SERVICE BULLETIN #0002 (rev. 2)

RELEASE DATE: 11/02/2021
EFFECTIVE DATE: 11/02/2021
SUBJECT: Reinforcement of the upper join between the centre and rear fuselages
MODELS AFFECTED: rev. 1 – Sling 4 and Sling 4 TSi (*all from SN#001 to SN#060*)
rev. 2 – Sling 4 and Sling 4 TSi (*all from SN#001 to SN#060 and non-parachute versions from SN#060 to #306*)
COMPLIANCE TIME: At the next MPI (*Mandatory Periodic Inspection*)
LABOUR TIME: Inspection only: 0.25 hours
Inspection & Repair: 2 hours

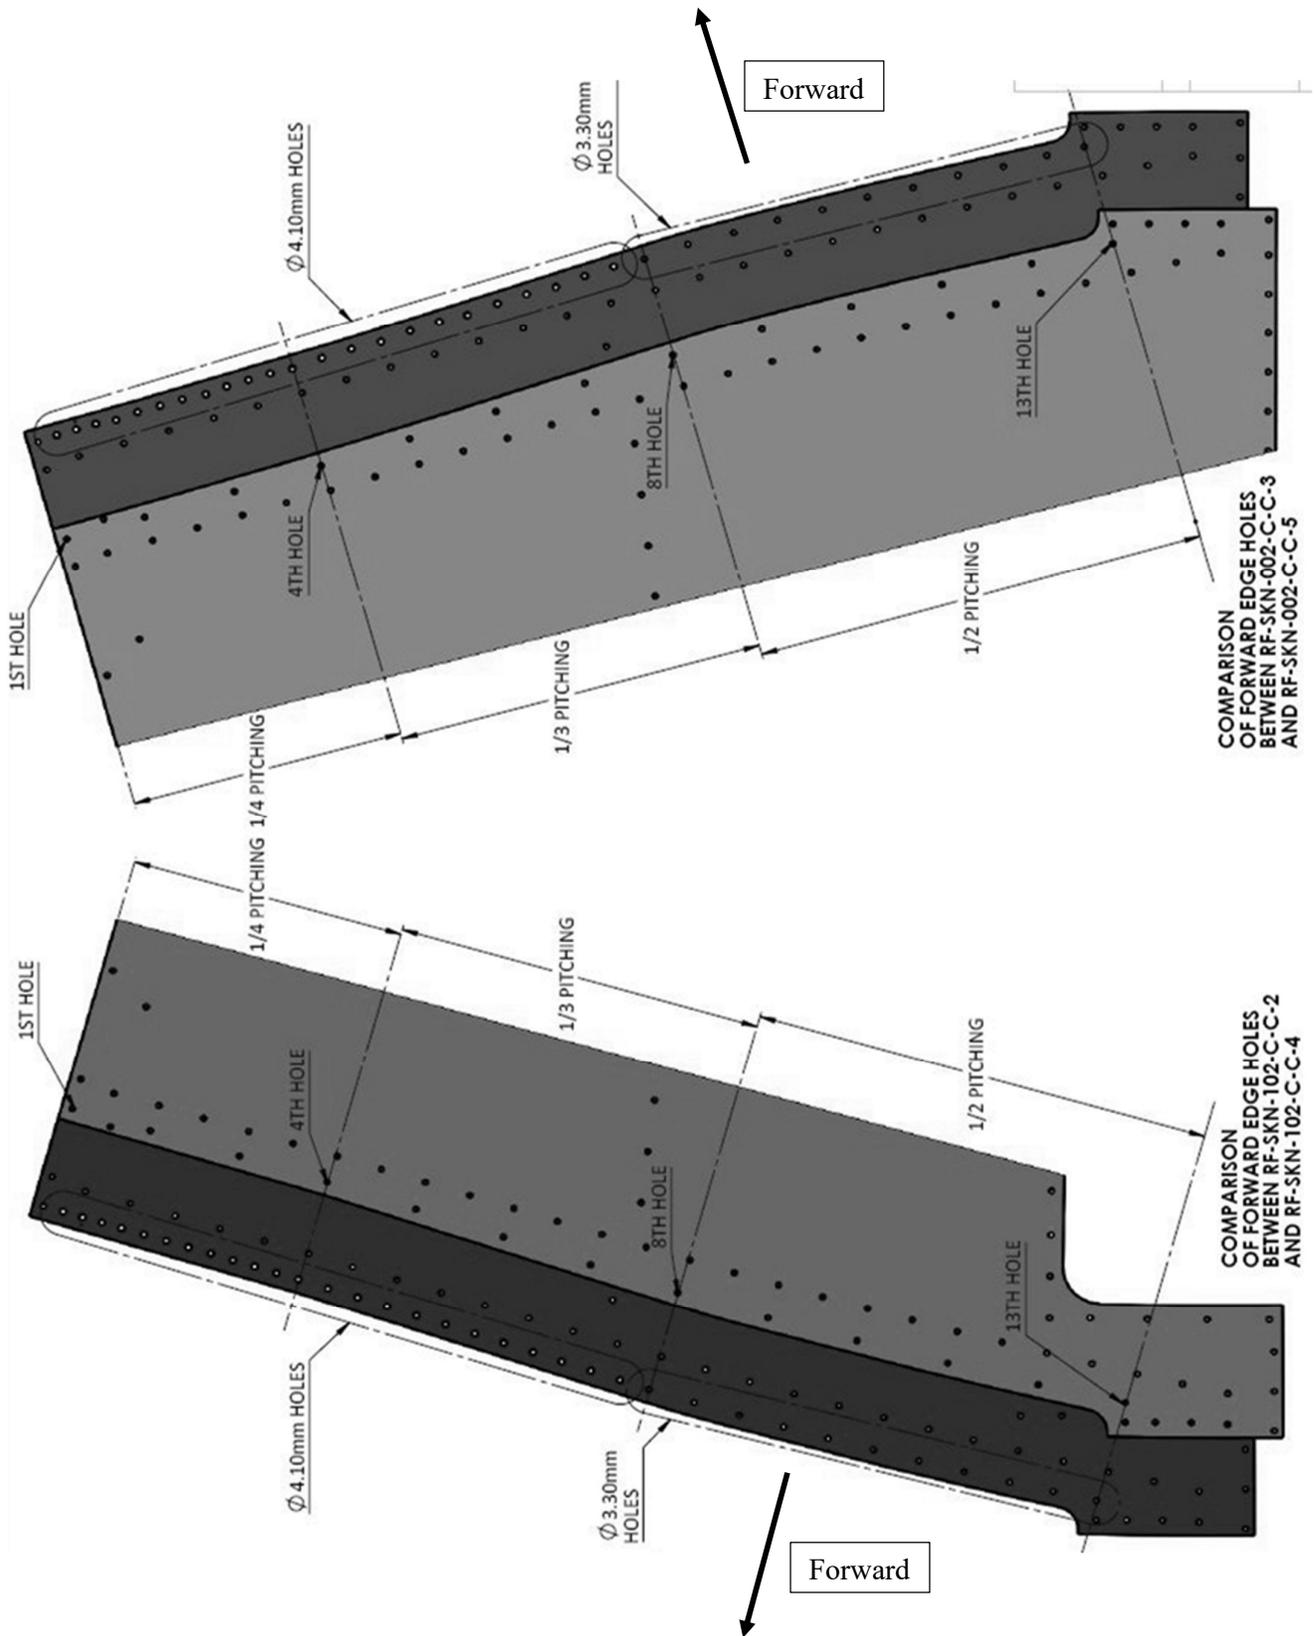
6. Use a 4.0mm (5/32") diameter drill bit to drill the holes marked as 4.10mm holes on the technical drawing and a 3.2mm (1/8") diameter drill bit to drill the holes marked as 3.30mm holes. Ensure to drill the holes in such a manner such that a correctly sized rivet flange will lie flush with the aluminum skin when fastened.

7. Pull the 3.2 x 8mm (1/8" x 5/16") and 4.0 x 10mm (5/32" x 3/8") multi-grip rivets with the pneumatic or hand operated pull riveter, whilst ensuring that the rivet flange lies flush with the aluminum skin.
8. Once the new rivets have been added, certain of the original 3.2mm rivets should be replaced with 4.0mm rivets. The regions with 1/3 and 1/4 pitching must contain 4.0mm rivets, and the quantity depend on if the aircraft is a parachute or non-parachute version. Please see attached drawings.
9. Remove the original, 3.2mm rivets, with a 4.0mm drill bit and continue to open the hole.
10. Fit and pull the remaining 4.0 x 10mm (5/32" x 3/8") multi-grip rivets with the pneumatic or hand operated pull riveter while ensuring that the rivet flange lies flush against the skin.
11. Touch-up the work completed with appropriate touch-up paint

6.1. PARACHUTE VERSION

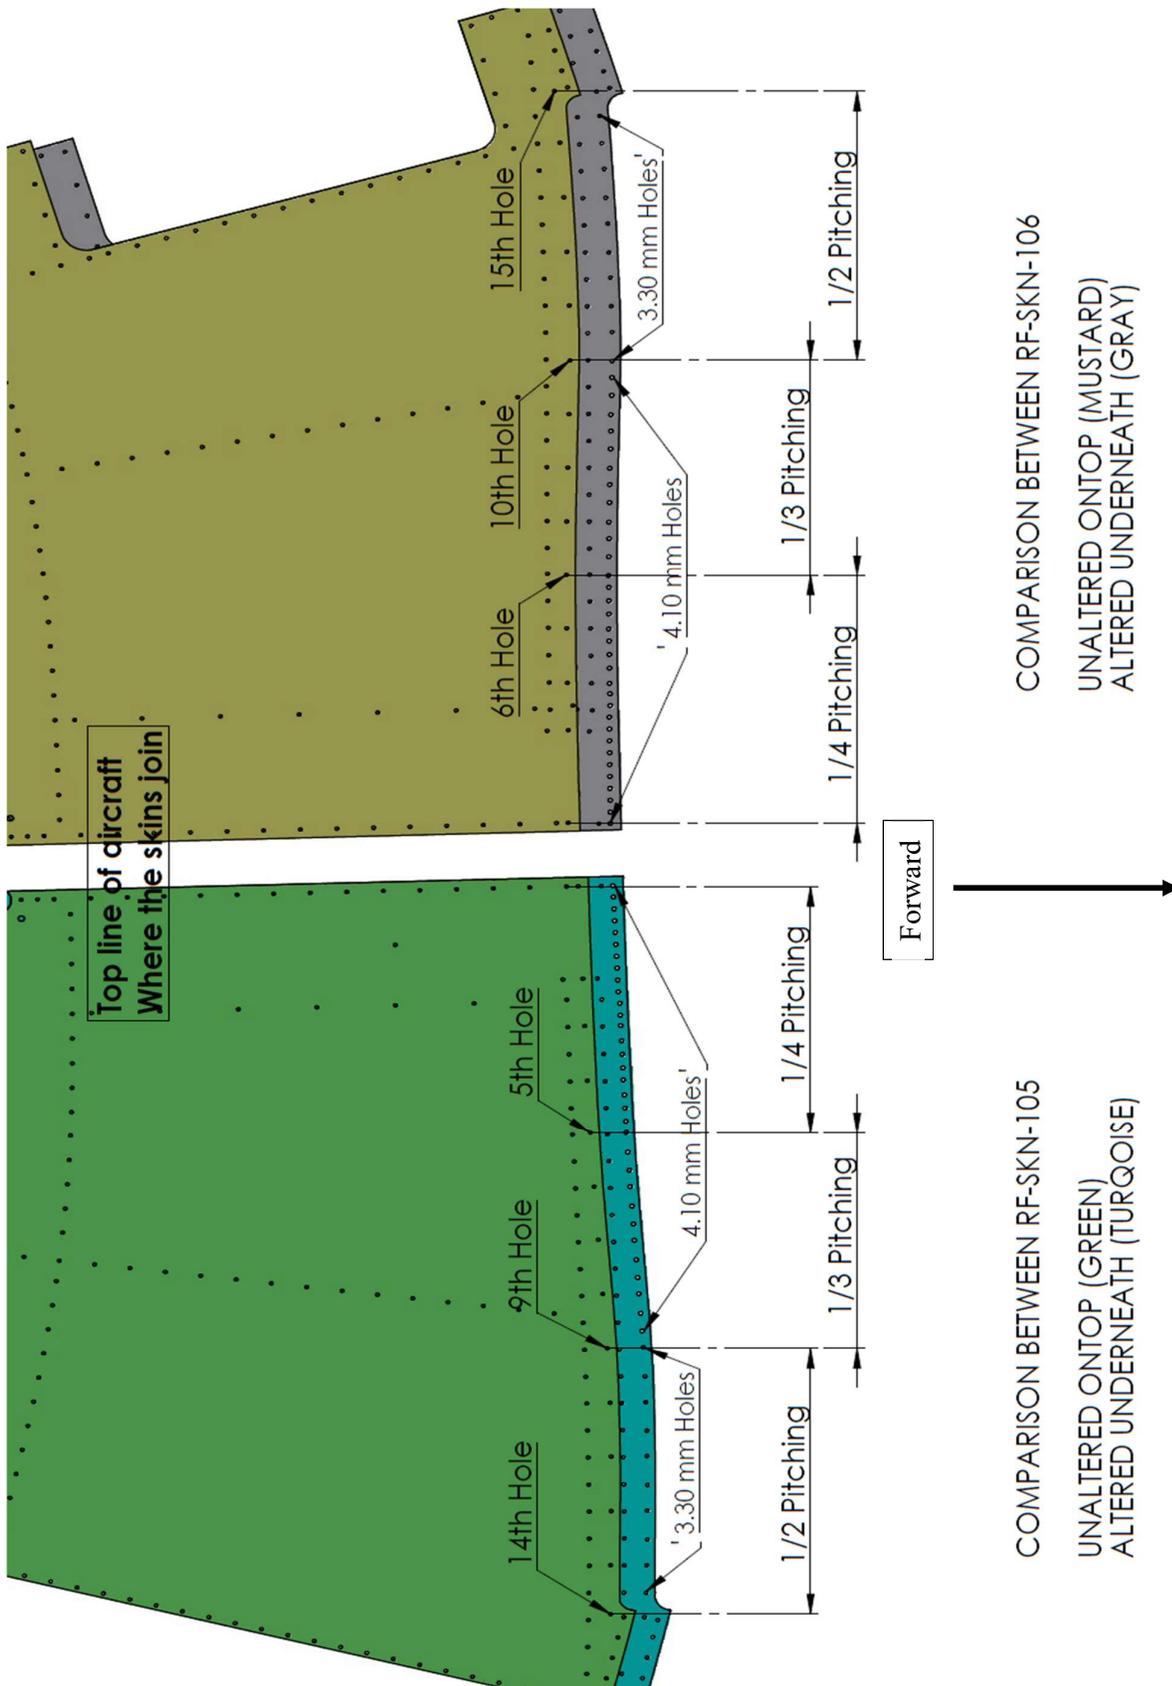
5. Use a ruler and a pen / pencil to mark-off the points along the curve where the new rivets will be inserted. 1/4 pitching (from the original rivet spacing) is required for the first set of holes, 1/3 pitching is required for the second set and 1/2 pitching is required for the last set of holes, from the top of the aircraft downwards. *Note – for parachute versions, the first holes will be covered by the parachute blowout skin and it is not required to remove this skin. Simply adjust the pitching in a practical fashion for the spacing of the first hole as close as possible to the parachute blowout skin edge.*

FIGURE 3 | ALTERNATIVE SPACING

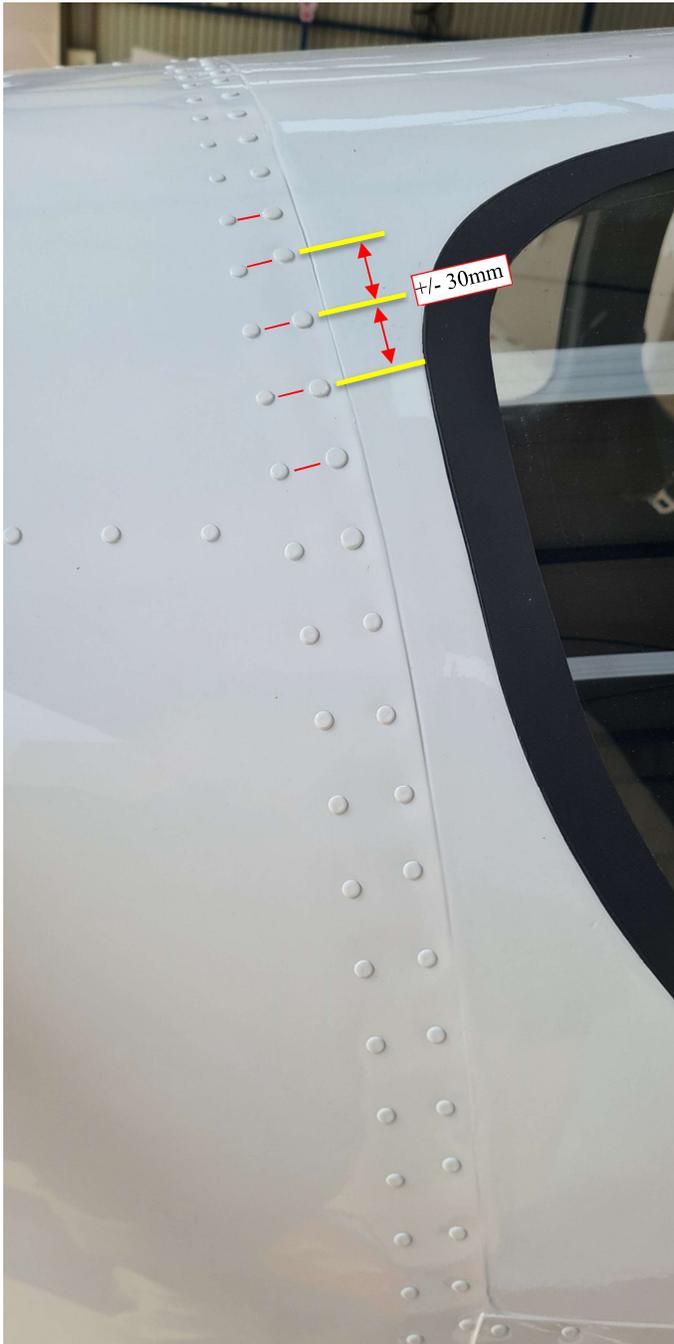
If the spacing of the rivets differs from the diagrams provided above, but has the same as seen in Figure 3 (left), then an alternative spacing is required. The red markup in the figure is to show that the forward and aft rivets are inline.

If moving from bottom to top, the pitching does not change from 1/2 to 1/3 (original pitching) as in the technical drawings in section 6. This is still a sufficient number of rivets in this section and are required to remain. If the rivets in this section are 3.3mm, then they are required to be drilled out and replaced with 4.0mm rivets, as described in point 8. in INSTRUCTIONS.

This requirement, in this appendix, is due to the original holes being misplaced in the 1/3 section, and if the diagrams/above instructions were to be obeyed, there will be an additional hole/rivet every 3rd rivet.

The additional rivets may be added in the 1/4 pitching section, as per diagrams in section 6.
